TO: ALL BIDDERS	FROM: Luis Ponce, P.E.
COMPANY:	DATE: May 11, 2015
ADDRESS:	TOTAL NO. OF PAGES INCLUDING COVER: 4
RE: City of Ferndale Addendum 1 BROWN ROAD CULVERT REPLACEMENT PROJECT PROJECT # SW2014-03

**ADDENDUM NO. 1**  
**To the Contract Provisions for**  
**CITY OF FERNDALE, WASHINGTON**

**BROWN ROAD CULVERT REPLACEMENT PROJECT**  
**PROJECT #SW2014-03**

BROWN ROAD  
 CULVERT REPLACEMENT PROJECT  
 PLAN AND PROFILE

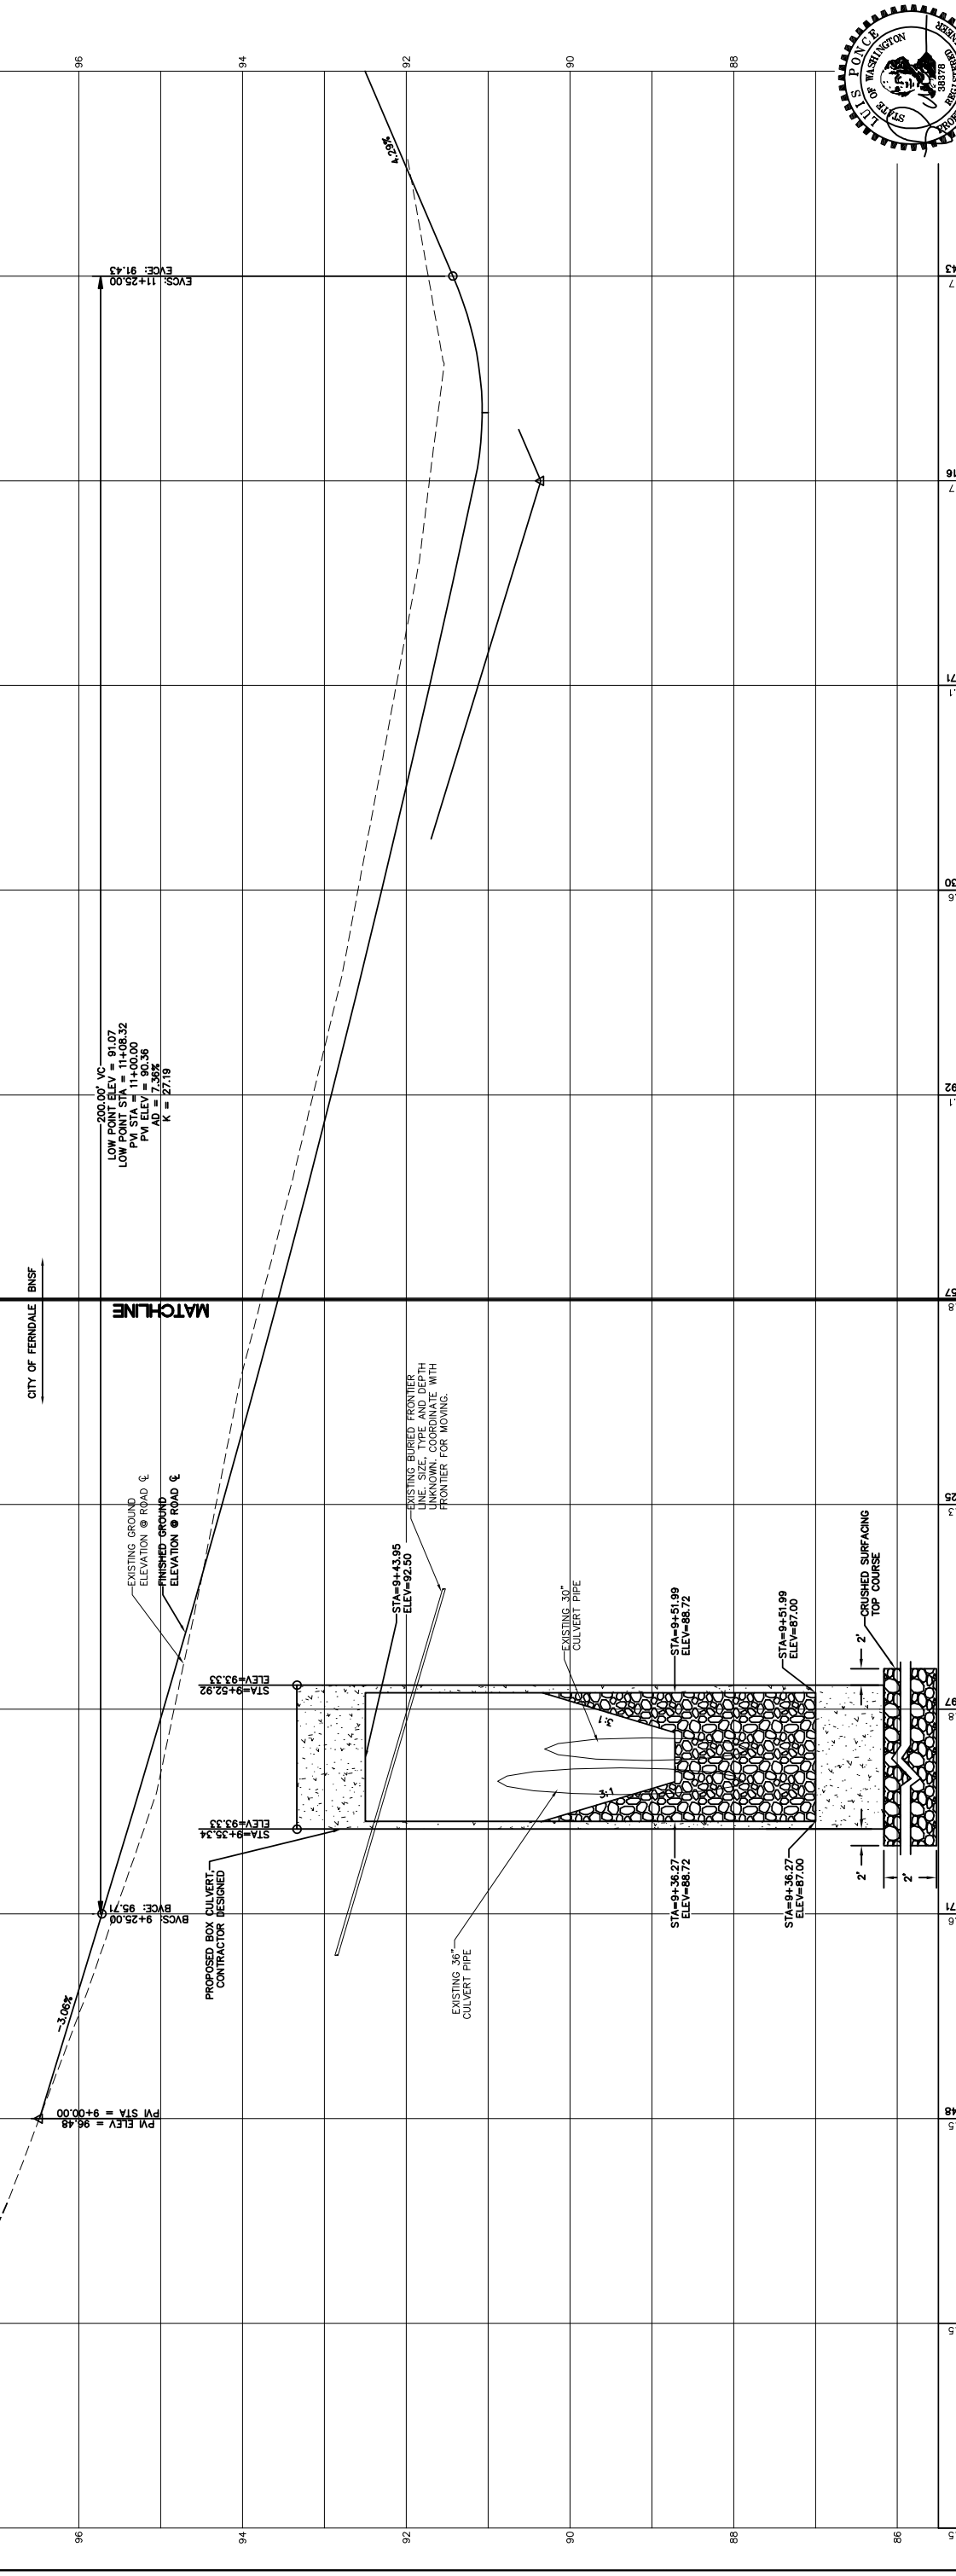
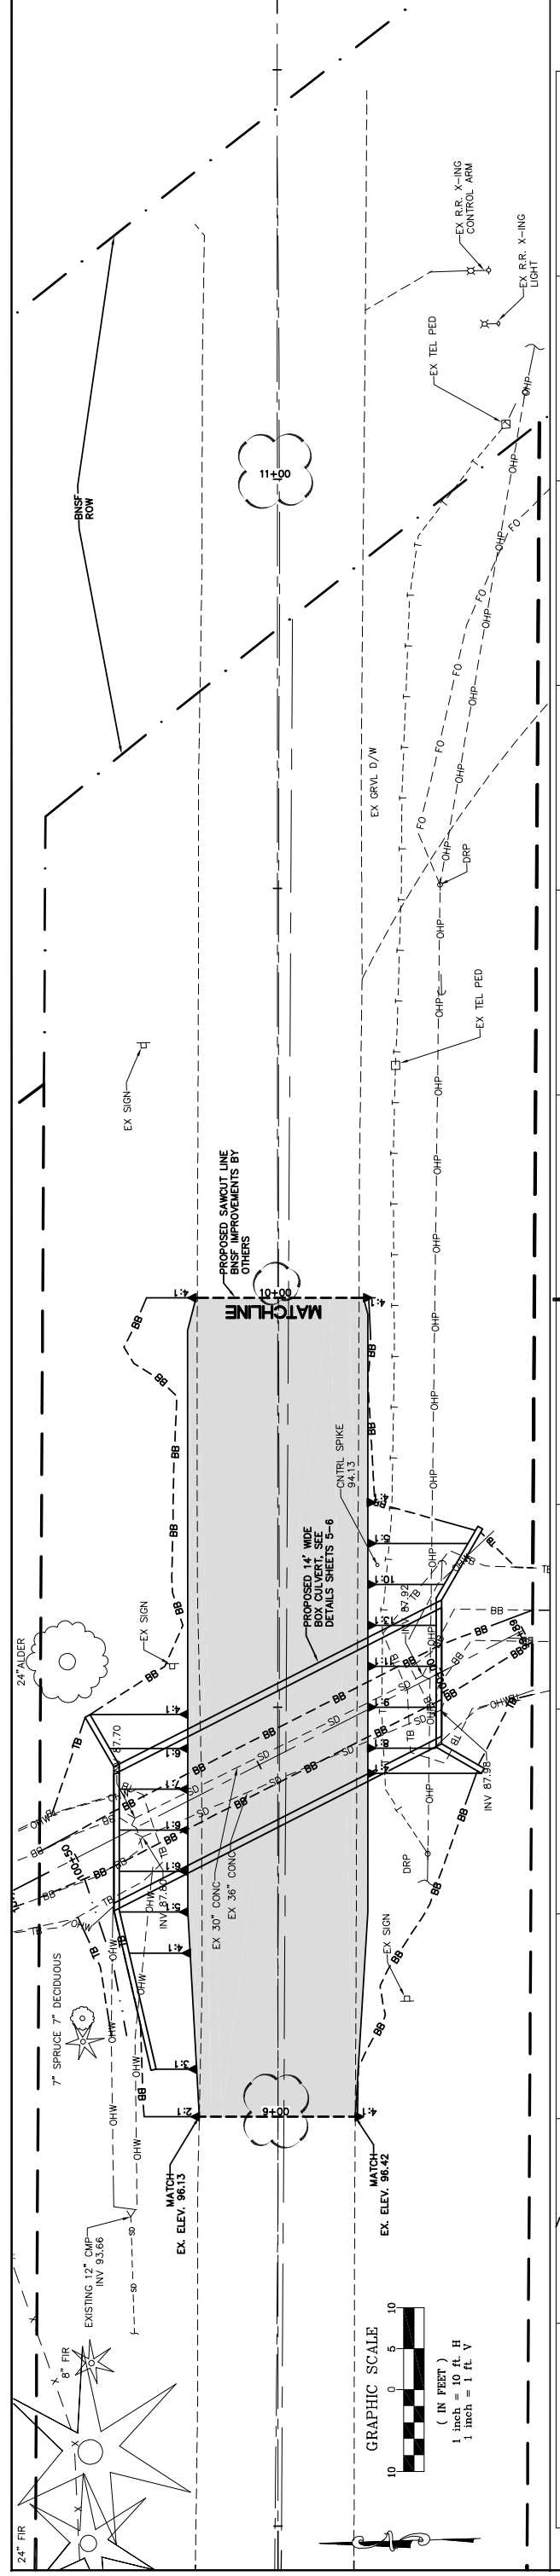
**Plan Sheet 4**

Stationing along the plan view centerline has been added.

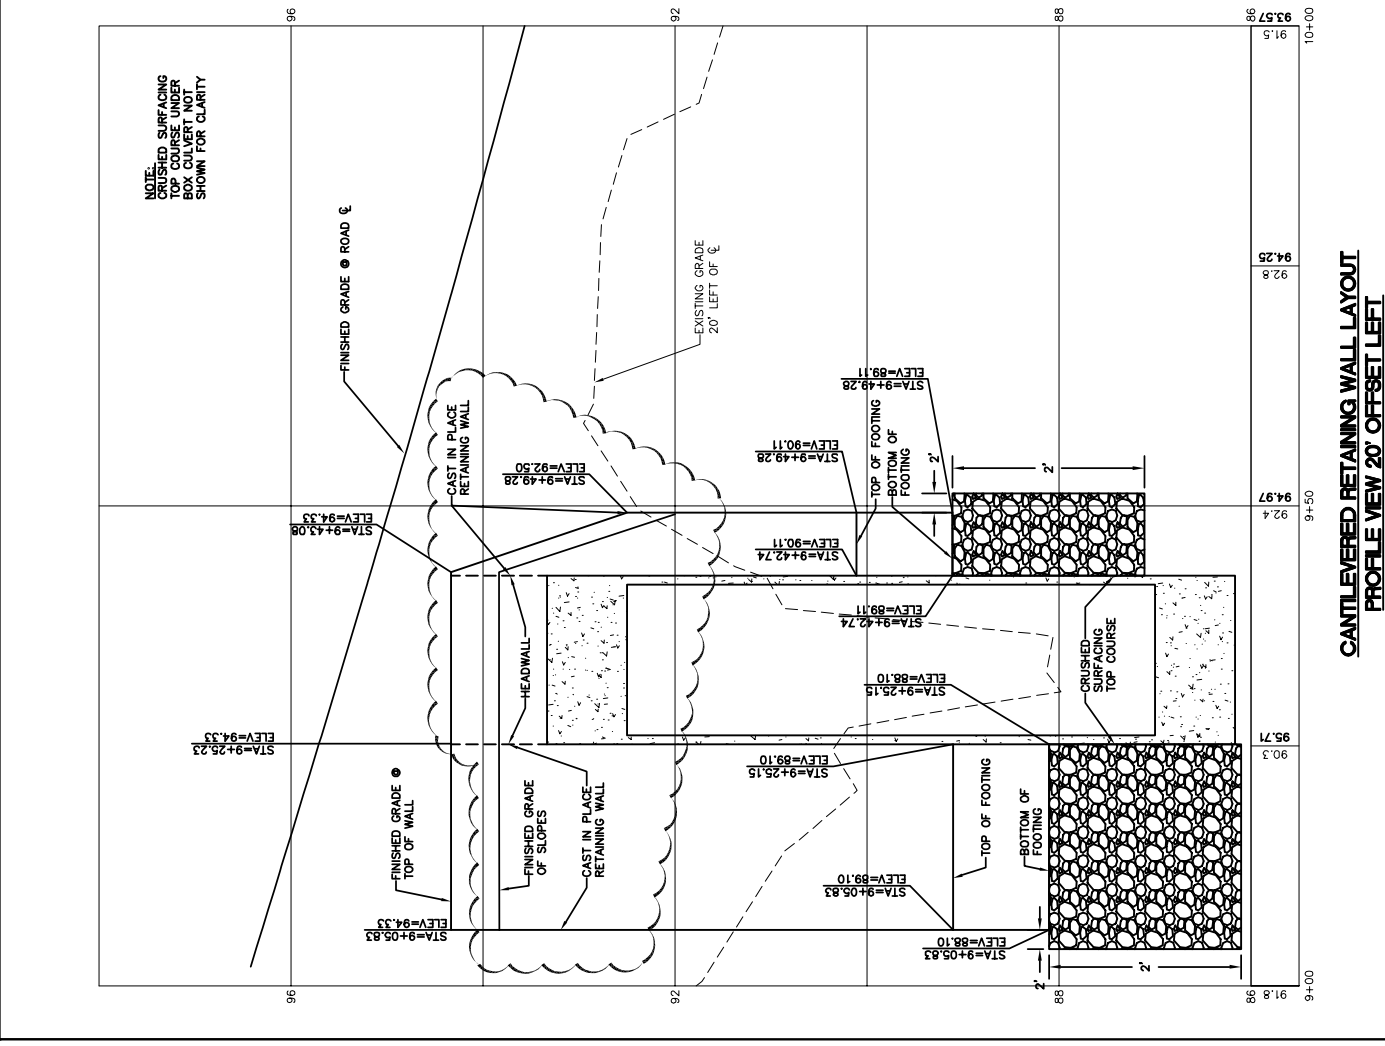
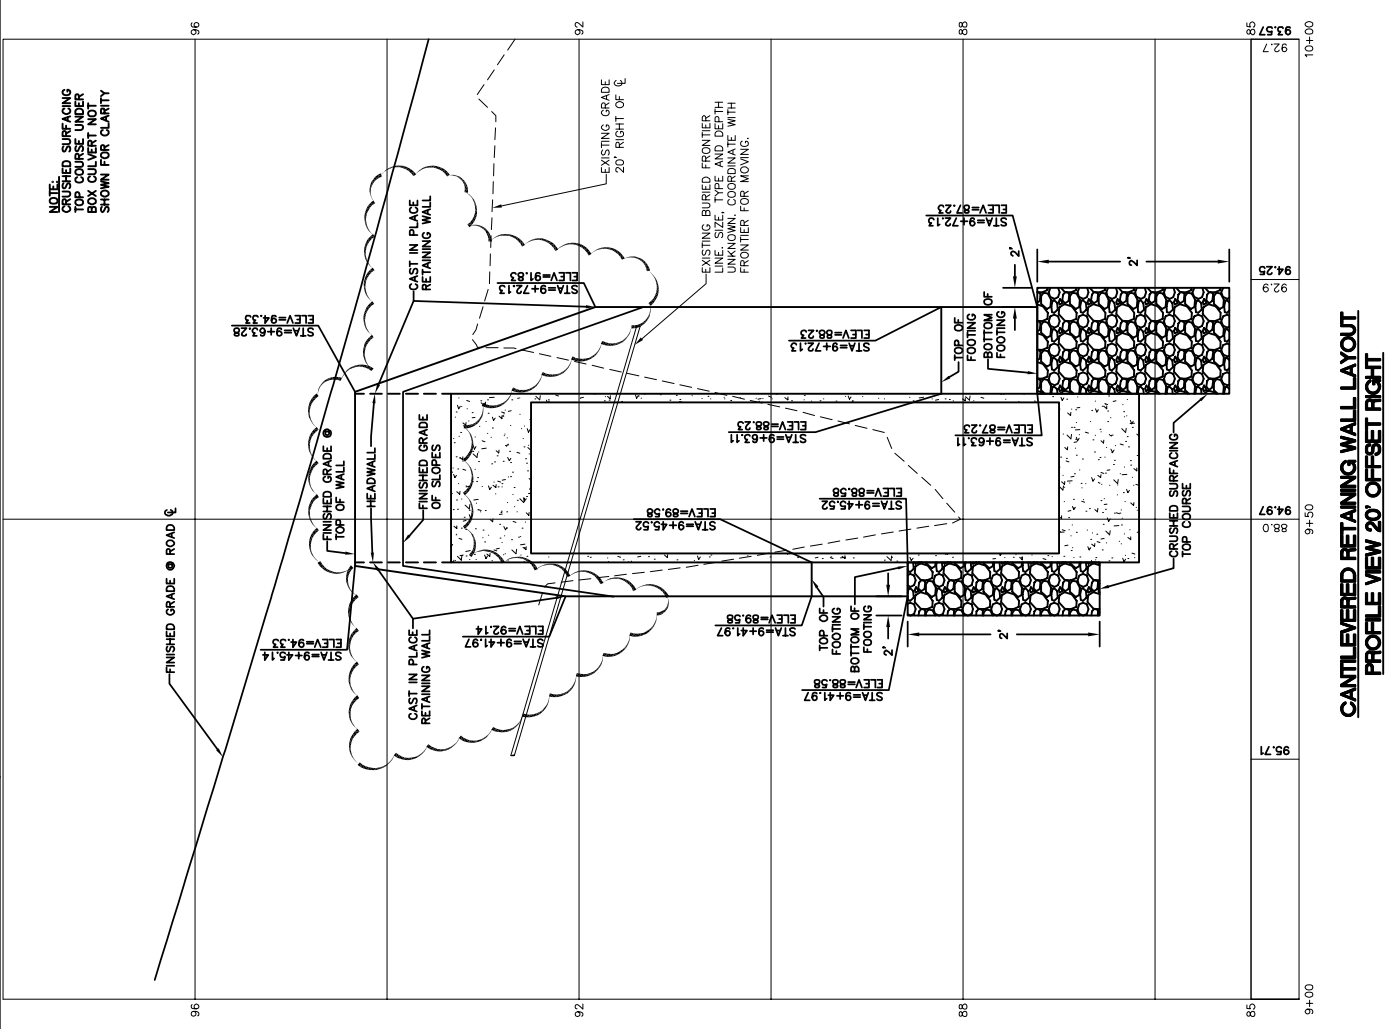
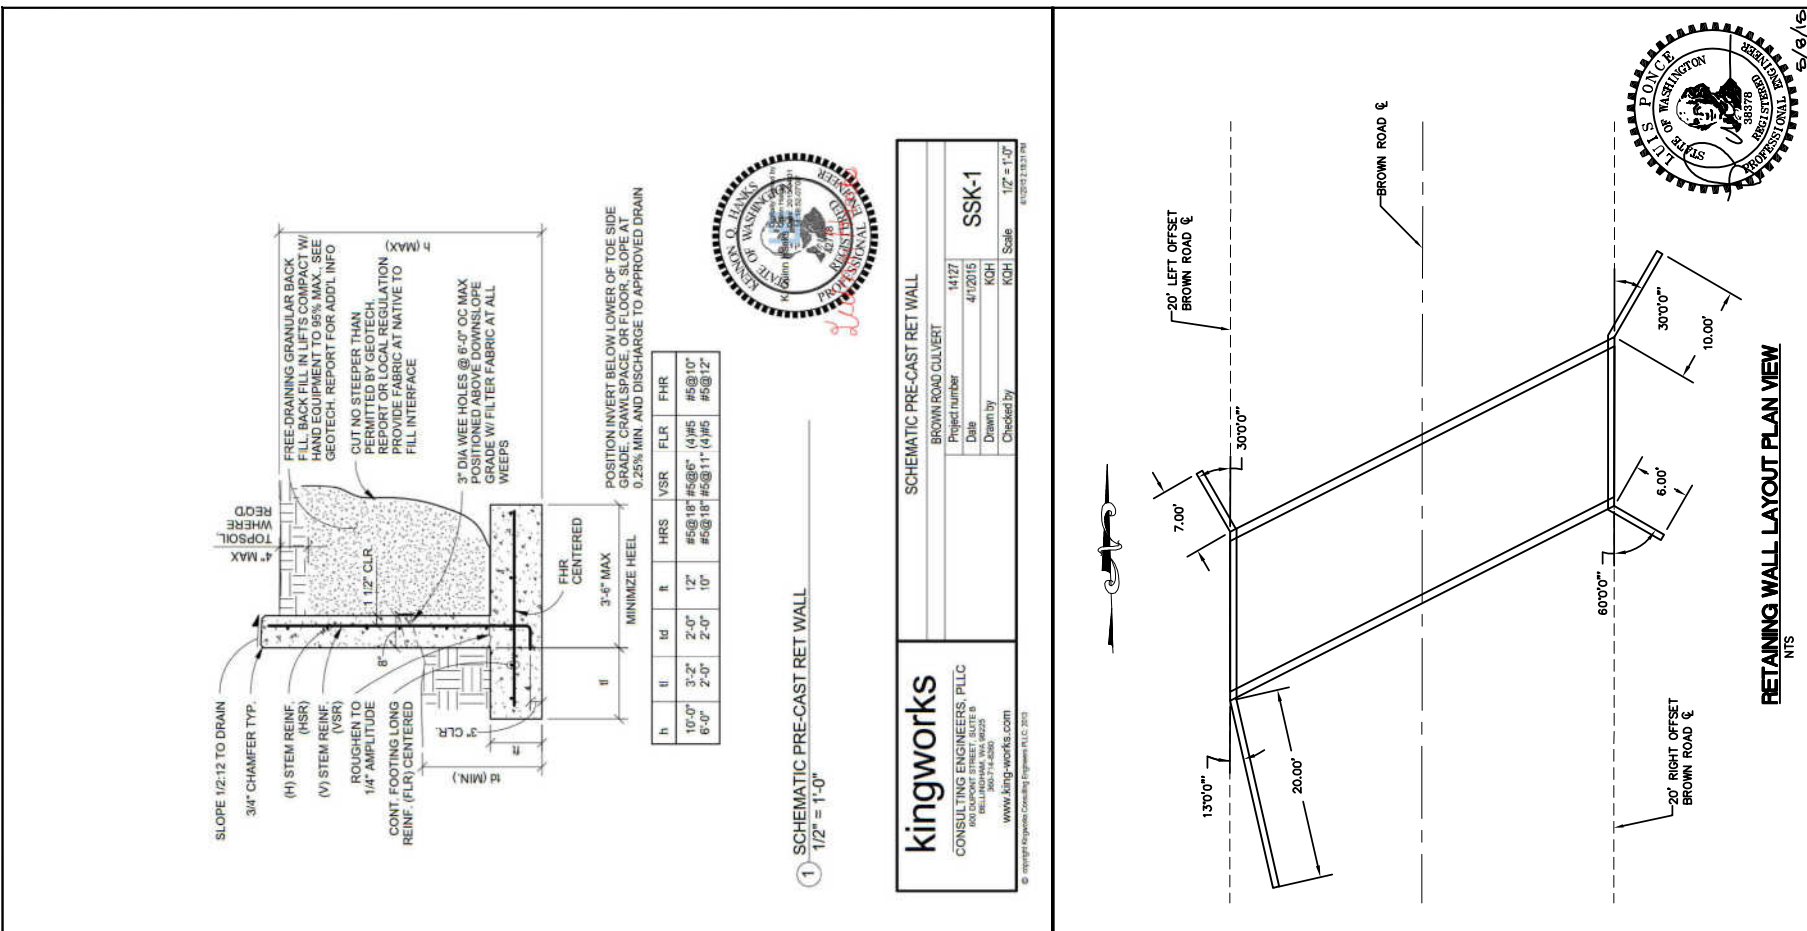
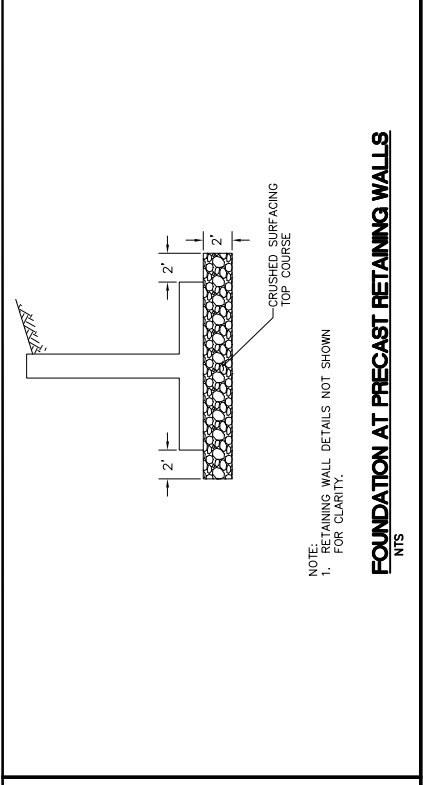
**Plan Sheet 6**

It is anticipated that the culvert and the retaining walls are two separate units. The attached Plan Sheet shows the two as separate structures.

The finished grade of the slope at the back of the structures has been added.
